TOWN OF BLACK MOUNTAIN

To: Town of Black Mountain Planning Board
From: Jennifer Tipton, Zoning Administrator
Re: Agenda Packet for April 22, 2019
Date: April 12, 2019

To: Black Mountain Planning Board  
From: Jennifer Tipton, Zoning Administrator  
Date: April 22, 2019  
RE: Padgettown Road Preliminary Plat

Regarding: Padgettown Road Subdivision  
Planning Department Review  
Response to Comments  
BEA Project No. 480918

Drawing Title:  
**EXHIBIT - BELLE GROVE RD ACCESS**

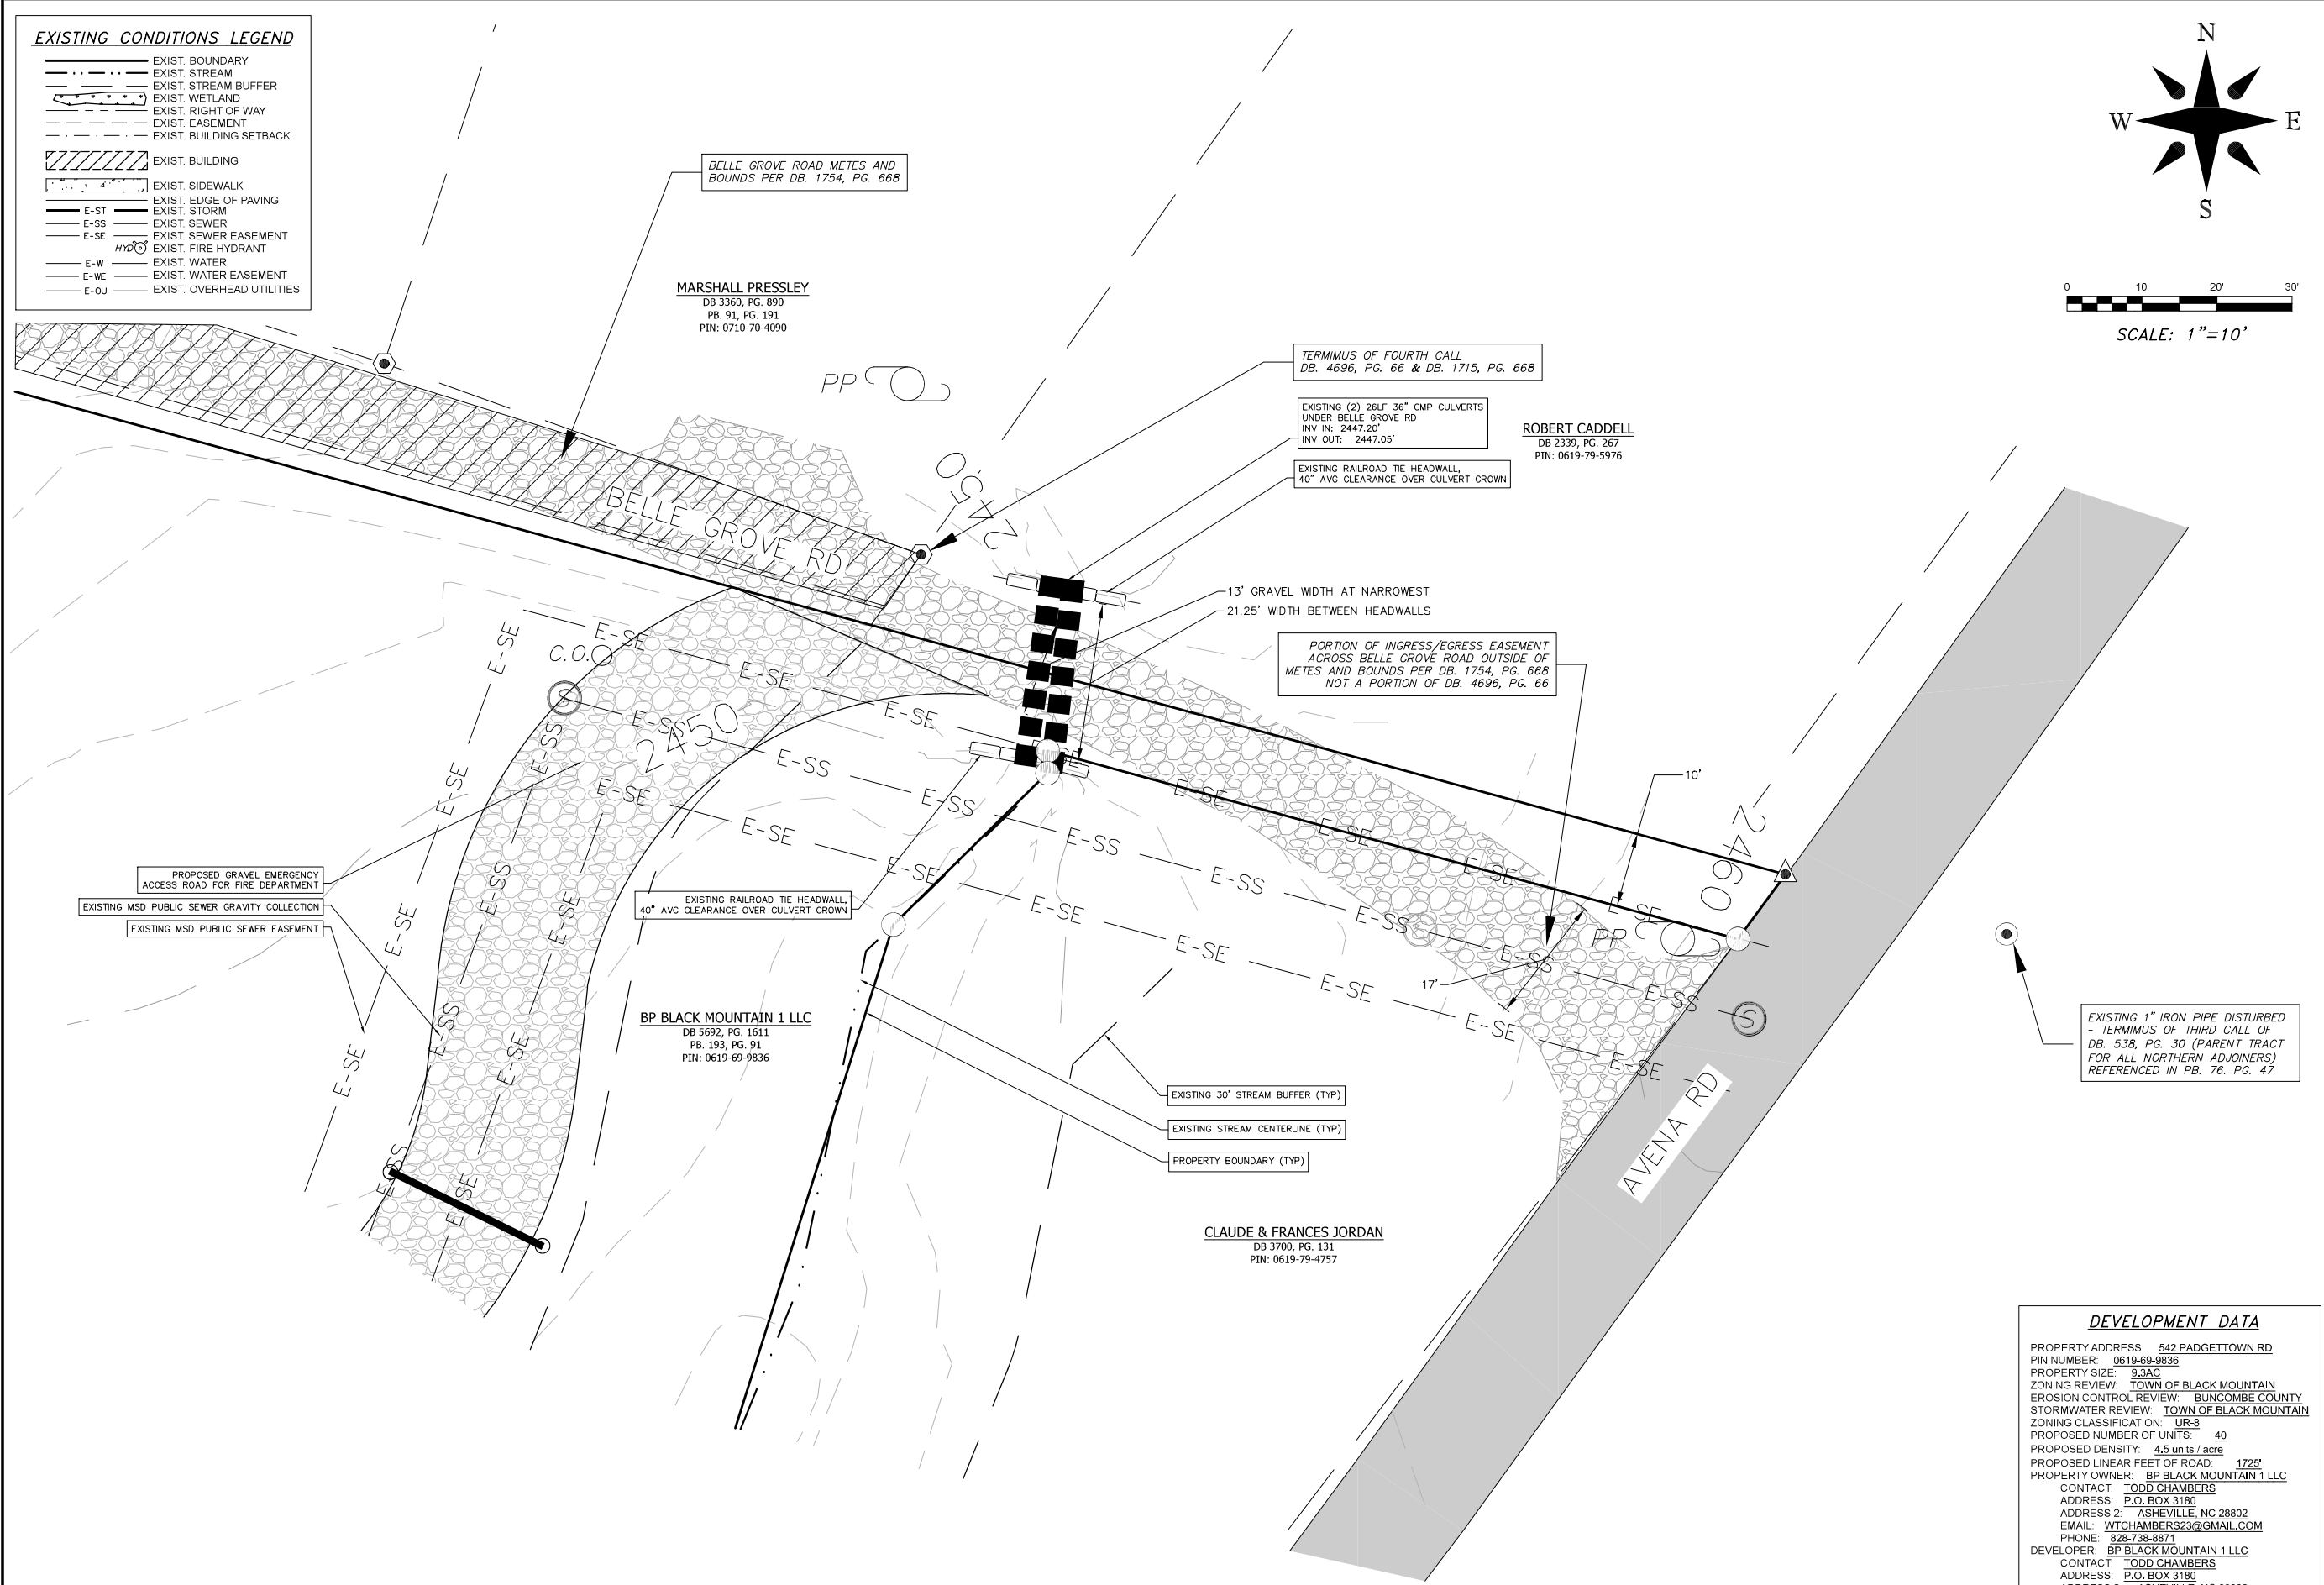
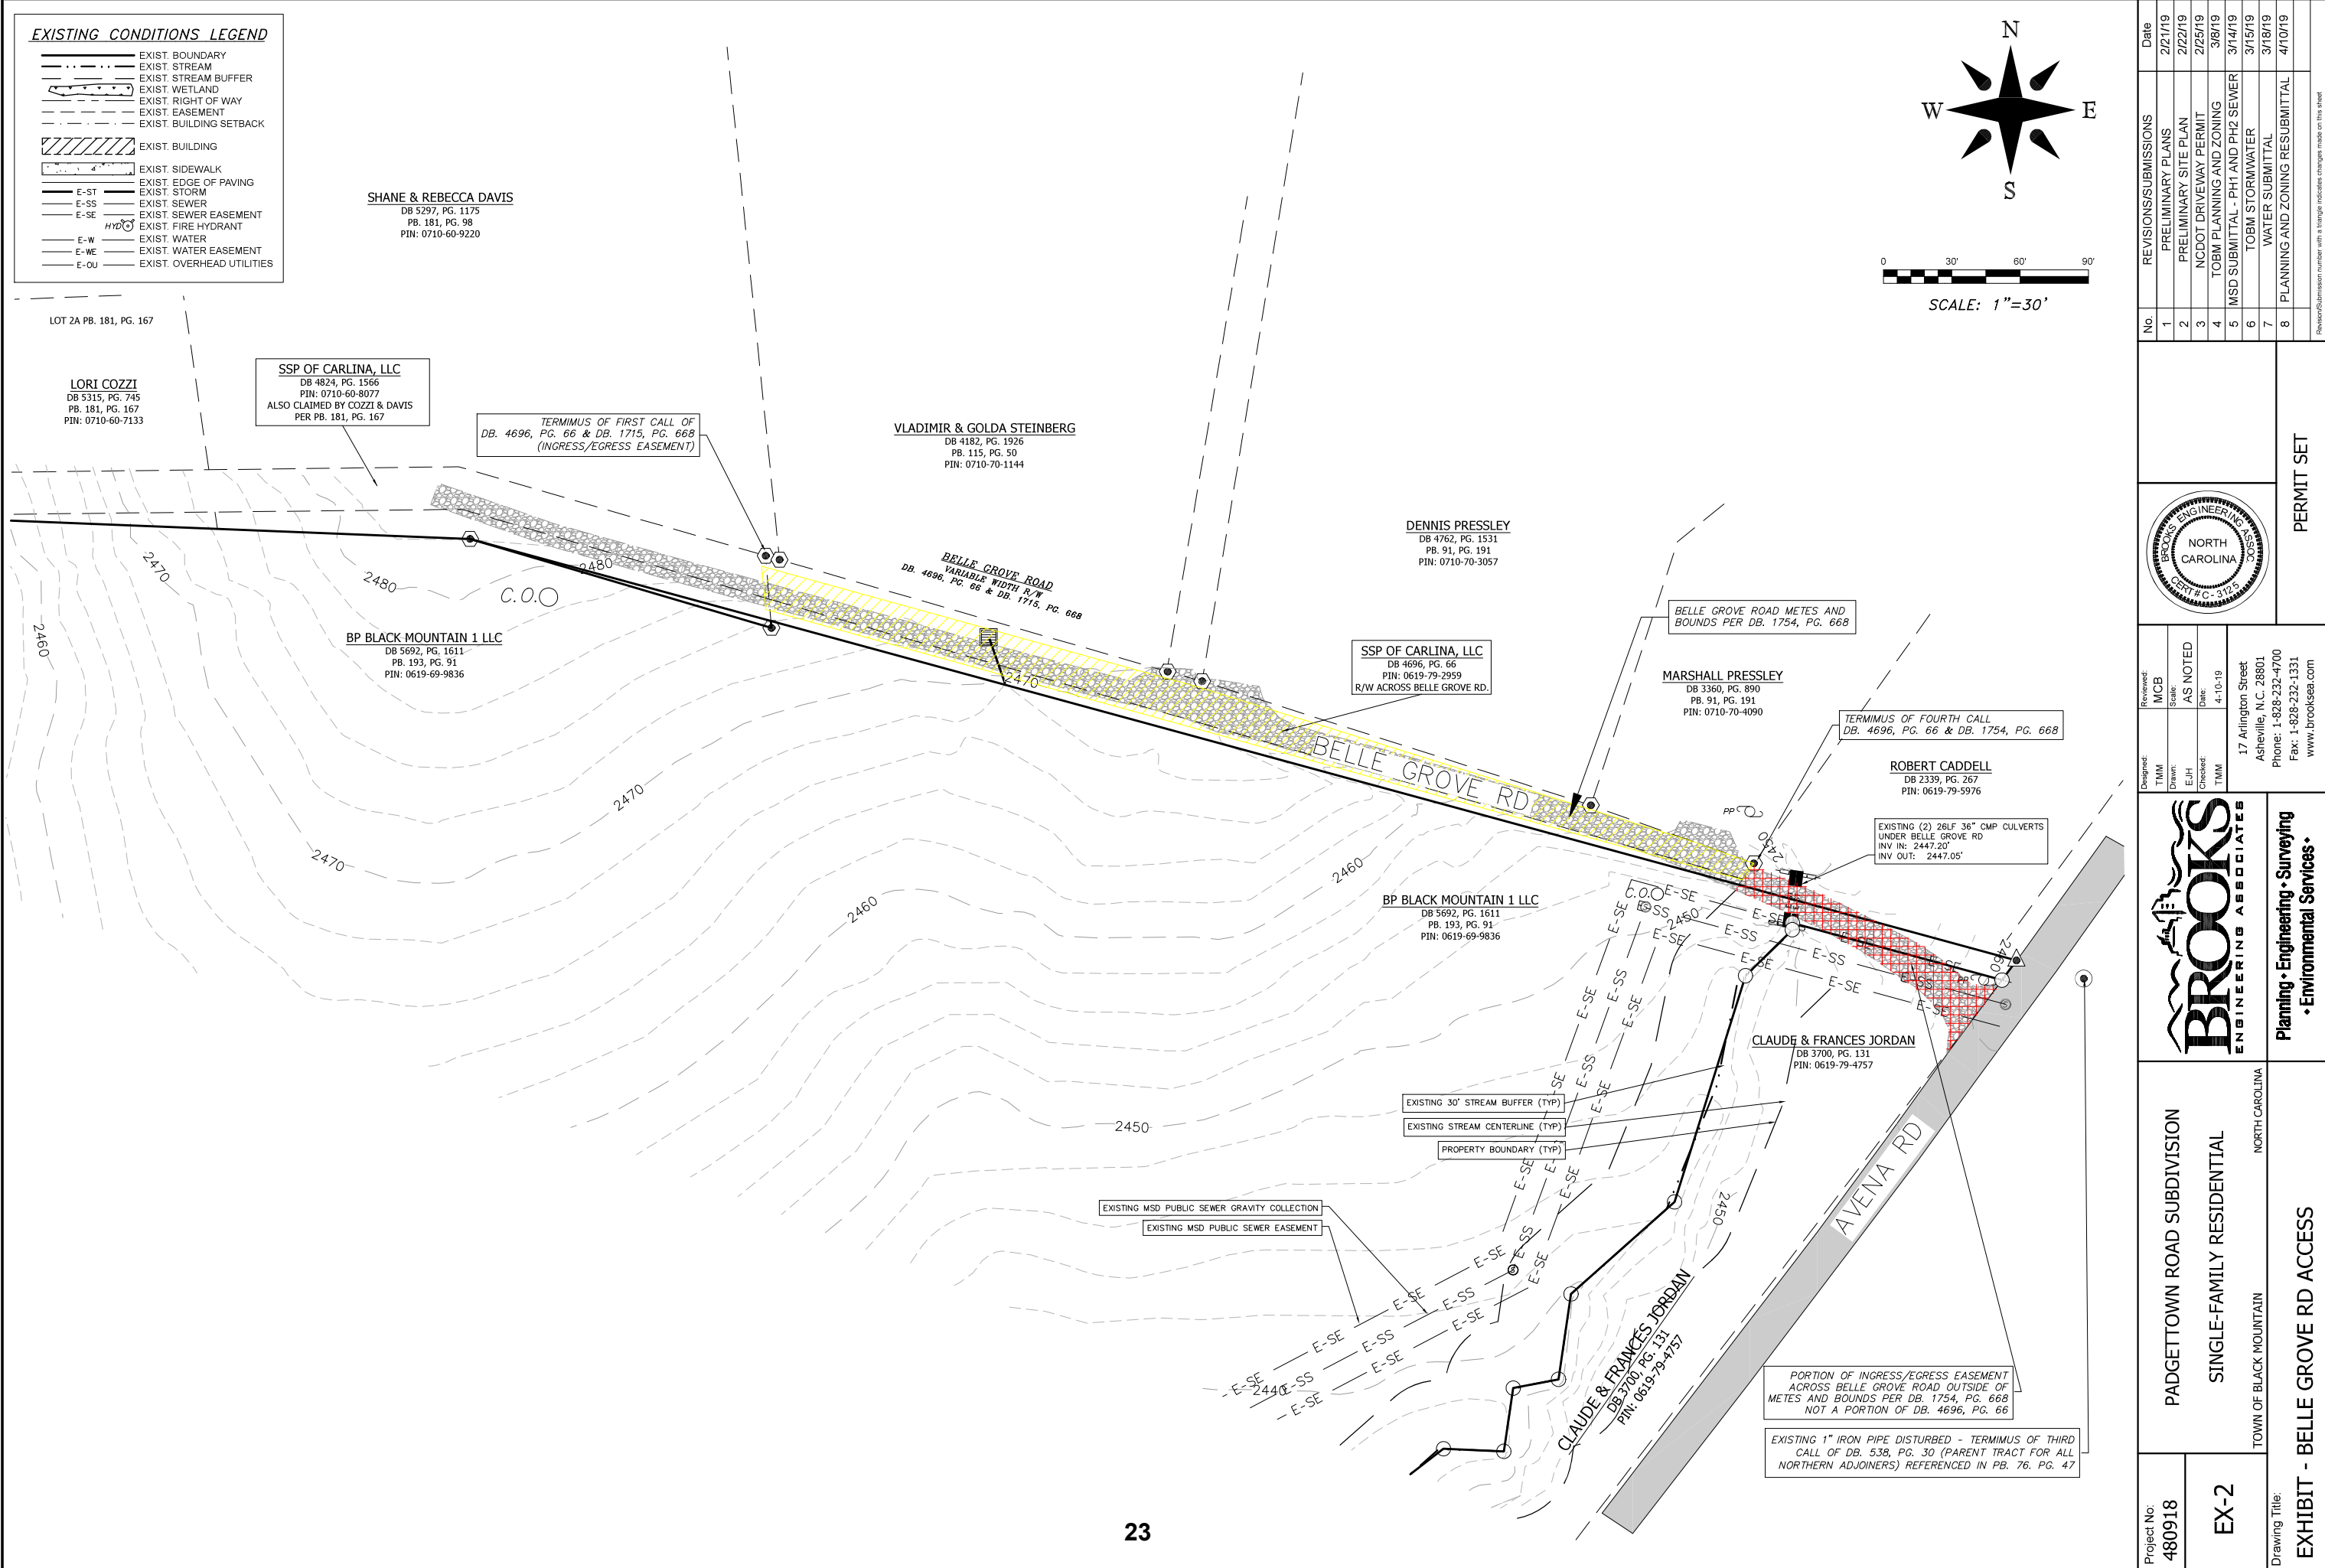
- *Planning Board would like to see the easement for access to Belle Grove Road or interpretation of easement access.*

Enclosed are two 11x17 drawings depicting the access to Belle Grove Road. One drawing depicts the easements prescribed by the deed. The other depicts our detailed survey of the existing conditions at the entrance to Belle Grove Road off of Avena Road. The intent is to utilize the entrance and access as it exists as that is what is interpreted as the legal access based upon our professional reading of the deed. This is also supported by a legal opinion rendered by Peter Henry regarding the site's legal access. A copy of deed with the applicable easement language highlighted is enclosed as well as copy of that opinion letter.

### Exhibit 3: Proposed signage for turnaround area

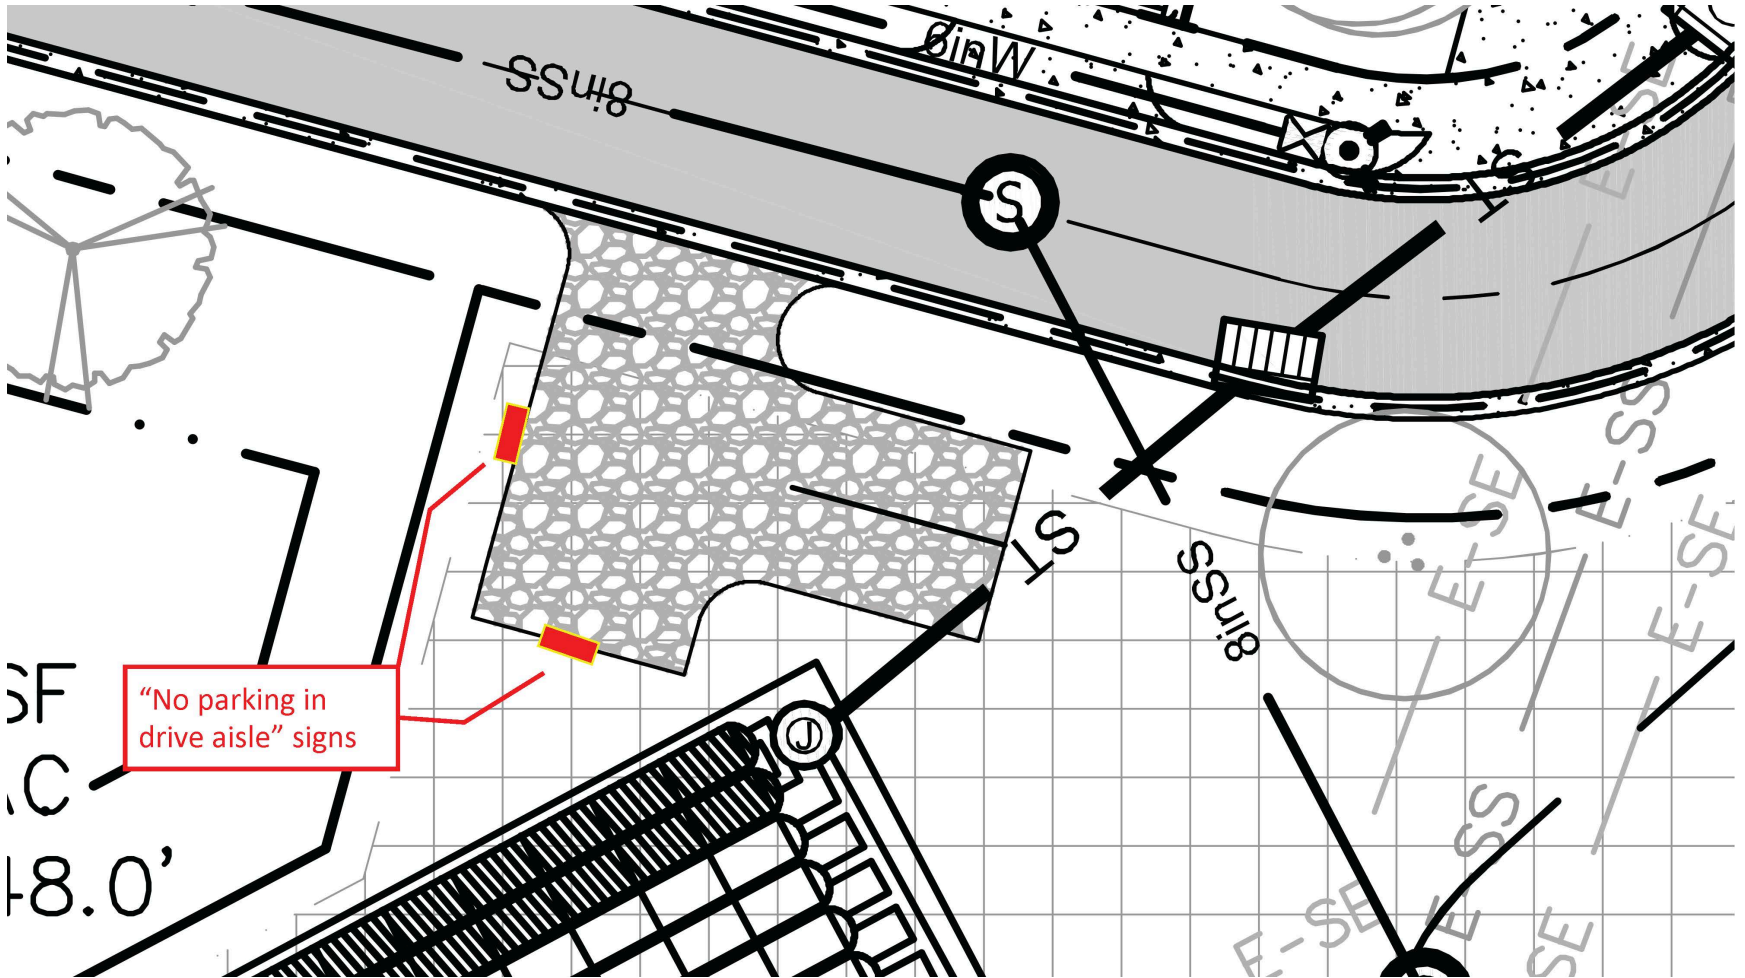
- *Planning Board would like to see turnaround at bottom of Blueview Drive*

It was our understanding from the March 25<sup>th</sup> meeting that the proposed parking lot for the greenspace at the end of Blueview Drive could also serve the dual purpose of a turnaround. We have amended the enclosed plans for a turnaround instead of the parking area per your letter's comment, but kindly request that the Town and Board reconsider this request based upon the discussion at the March 25<sup>th</sup> meeting. Both BEA and the owner would like to retain the previously submitted plan utilizing the gravel parking area for a turnaround to reduce impervious area and preserve more open space and soften the contrast of the development against the natural background.
